**Response to U.S. EPR Design Certification Application RAI No. 262**

**Response to  
Request for Additional Information No. 262 (3292), Revision 0**

**U. S. EPR Standard Design Certification  
AREVA NP Inc.  
Docket No. 52-020  
SRP Section: 19 - Probabilistic Risk Assessment and Severe Accident Evaluation  
Application Section: 19.2**

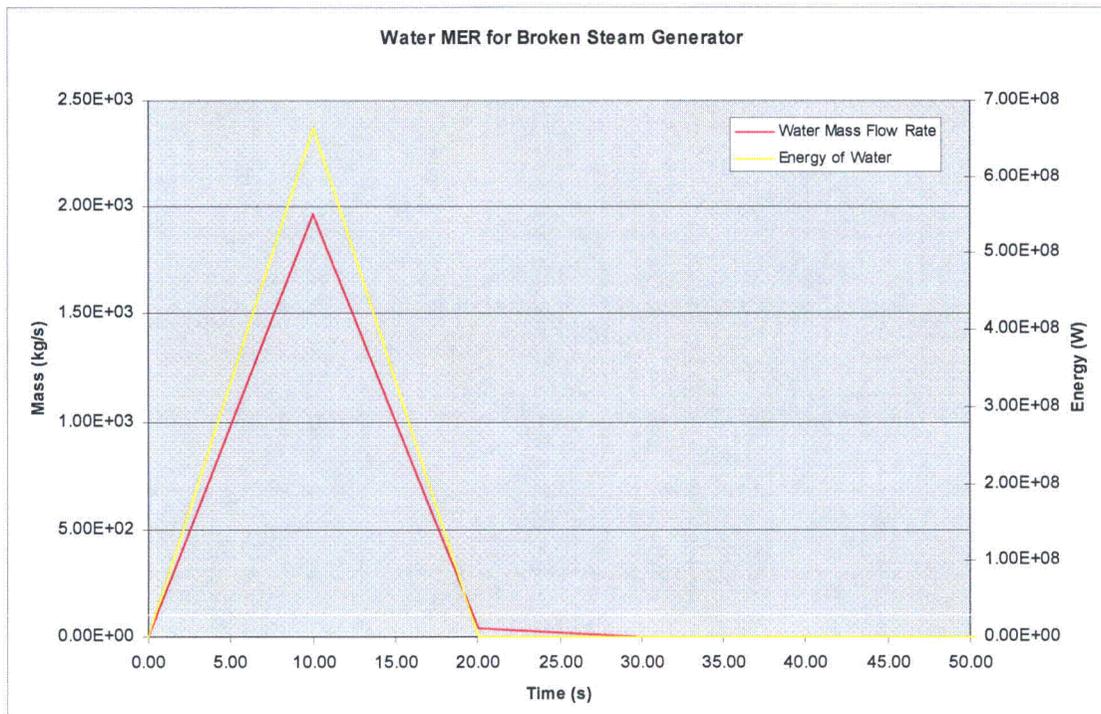
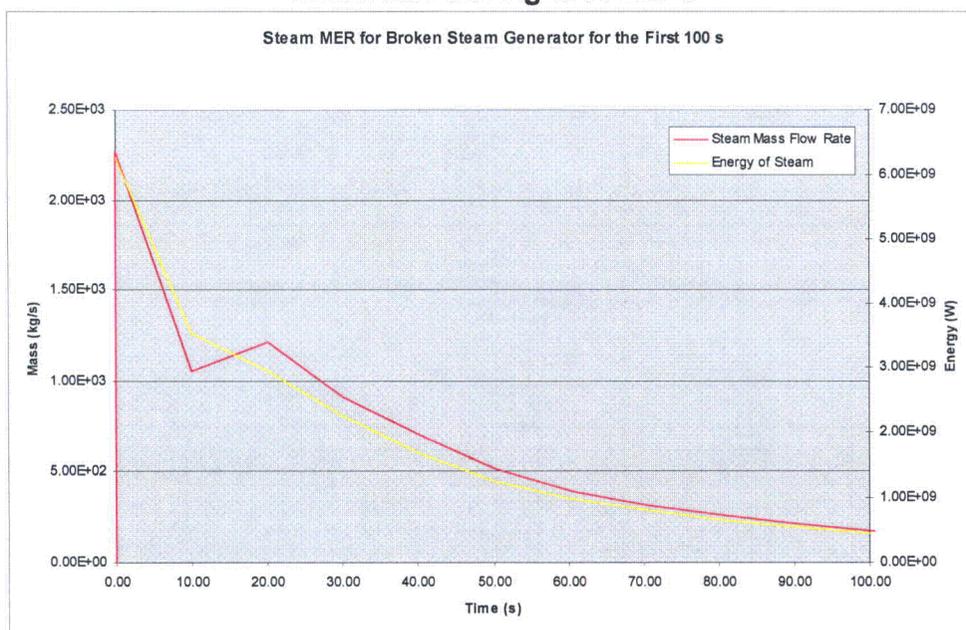
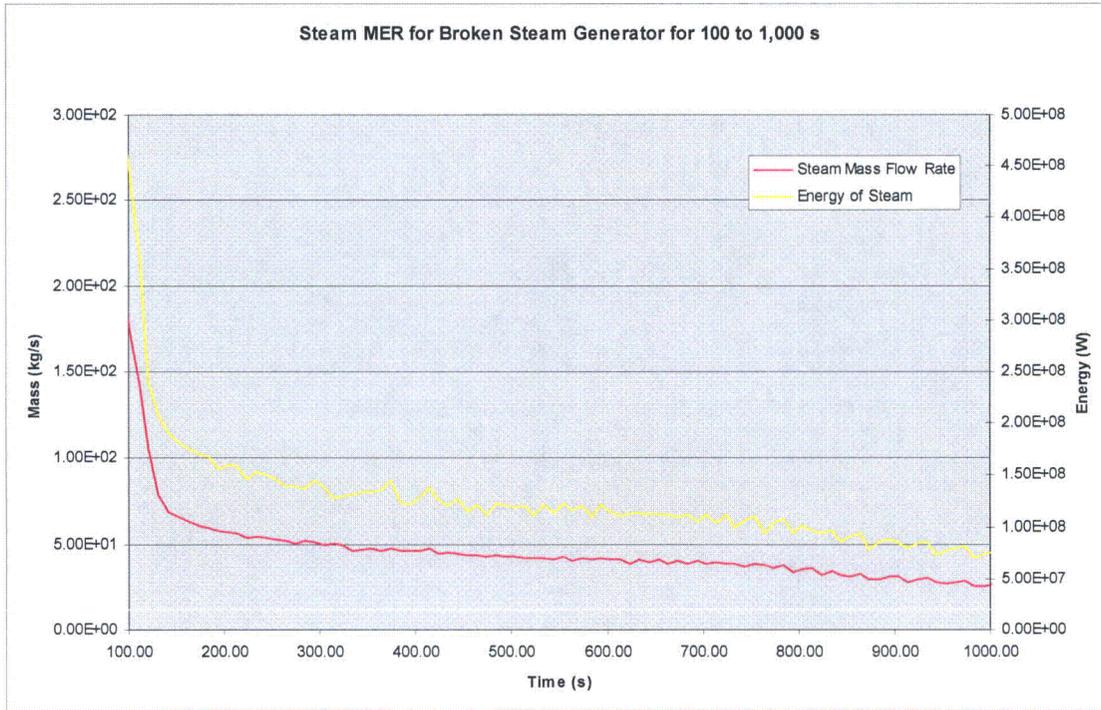
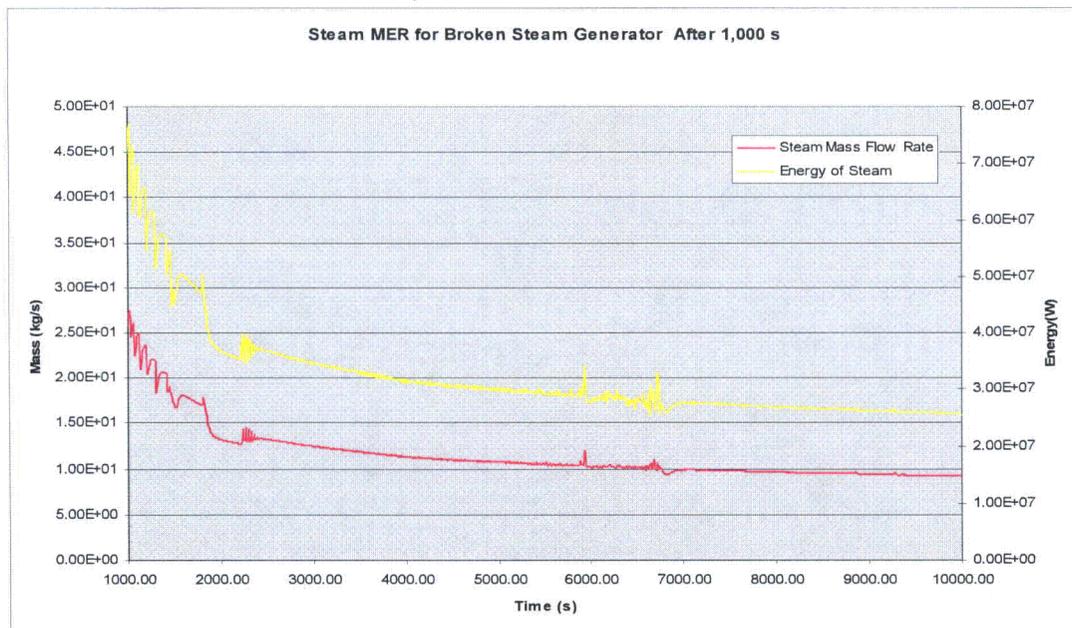
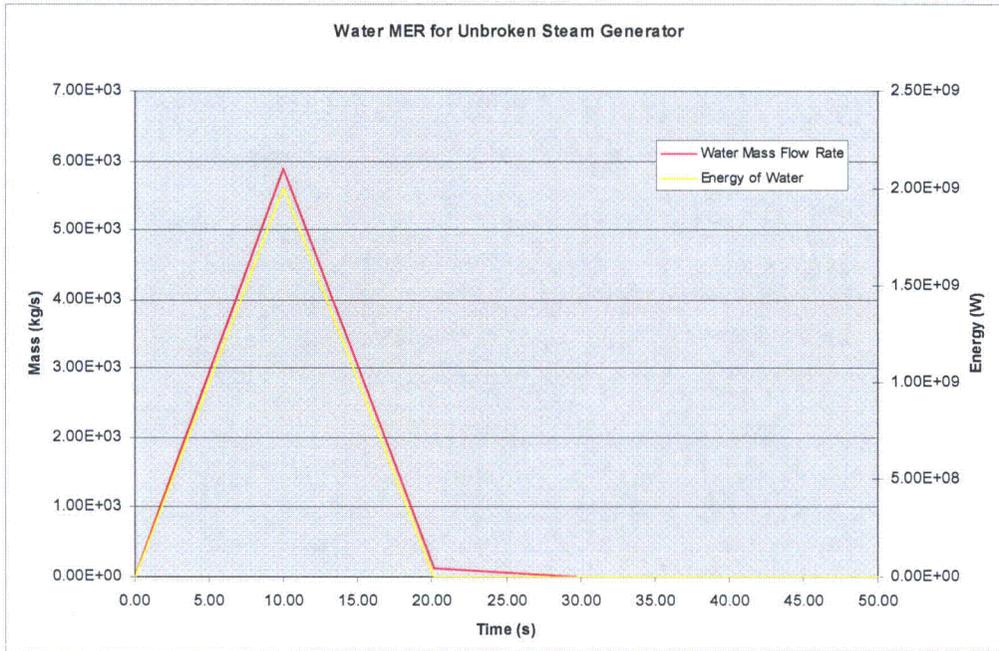
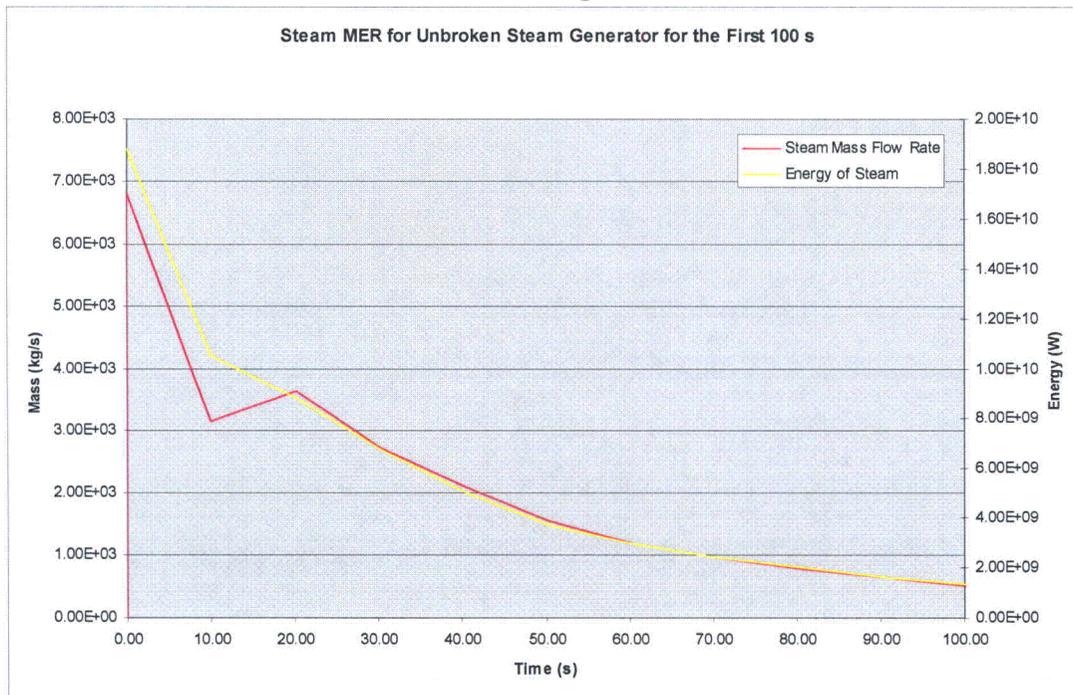
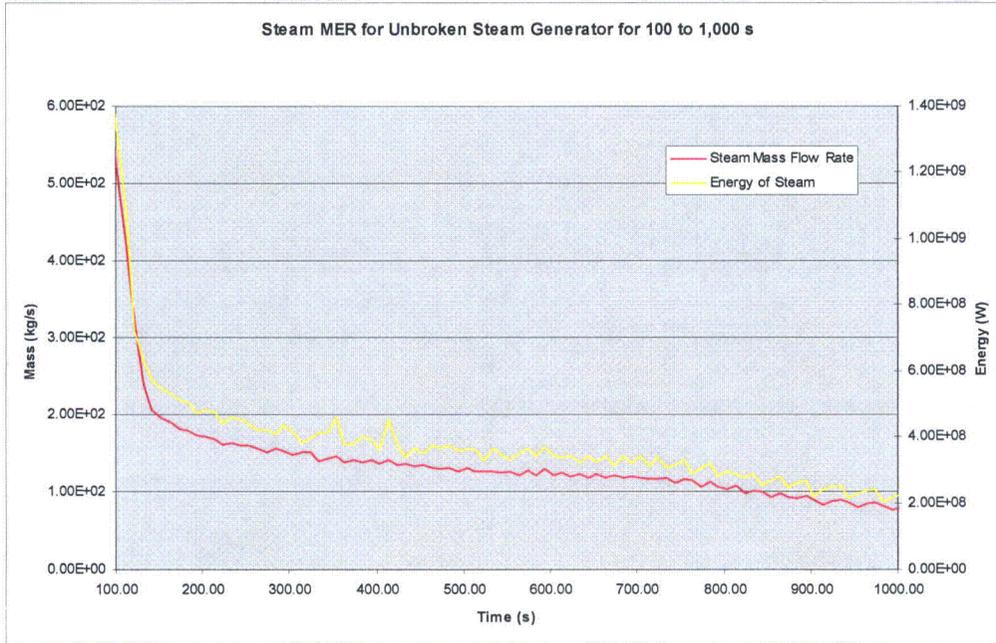
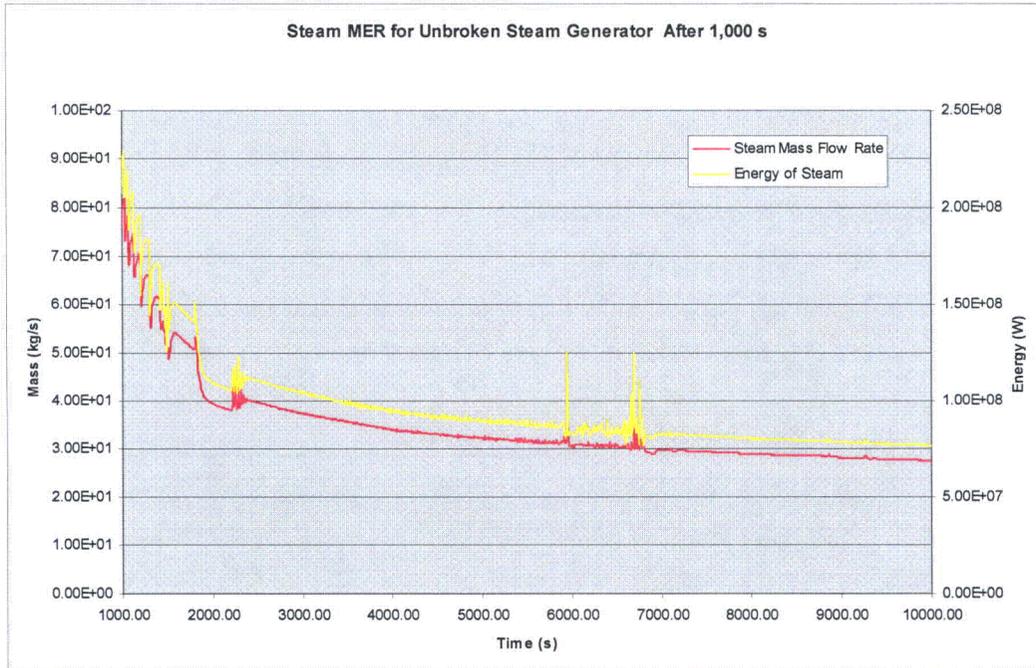
- e) Please provide the mass and energy flow rate out the break that was used in MAAP calculation of the containment transient following a main steam line break.

The question refers to MAAP source term calculations st1\_1\_5bar, st1.5, and st1\_10a performed to support the Level-2 probabilistic risk assessment (PRA). However, none of these calculations contain a main steam line break (MSLB) inside containment. An analysis of a MSLB inside containment was provided in the Response to RAI 22, Supplement 3, Question 19-160. The mass and energy releases (MERs) calculated by the MAAP simulation in the Response to RAI 22, Supplement 3, Question 19-160 are also used in this response.

The MAAP model used in the representation of the MSLB within containment provides two sets of data. The first set is for the releases from the "broken steam generator (SG)" representation, which models one SG, one reactor coolant pump (RCP), and the associated piping. The second set of releases is from the "unbroken SG" representation, which models three SGs, three RCPs, and associated piping. In a typical MAAP analysis, releases will only occur from the "broken SG" set; however, to maximize containment pressurization, a break was assumed in both sets of representations.

For each SG representation set, four variables are used in delineating the MERs. These variables represent the mass flow rate for the water and steam (kg/s) and the associated energy release rate (W). The mass flow rate that the MAAP model provides is the average flow rate over multiple plot time steps. This average value provides a better representation of the total flow rate instead of the instantaneous value in which a spike may have been missed.

Figure 19-322e-1 through Figure 19-322e-8 provides the MERs for the two sets of SG representations. Figure 19-322e-1 and Figure 19-322e-5 show that the water mass flow rate peaks at around 10 seconds and then drops to near zero after approximately 20 seconds after the start of the accident. The steam MERs are divided among three plots: Figure 19-322e-2 to Figure 19-322e-4 for the "broken SG" and Figure 19-322e-6 to Figure 19-322e-8 for the "unbroken SG."
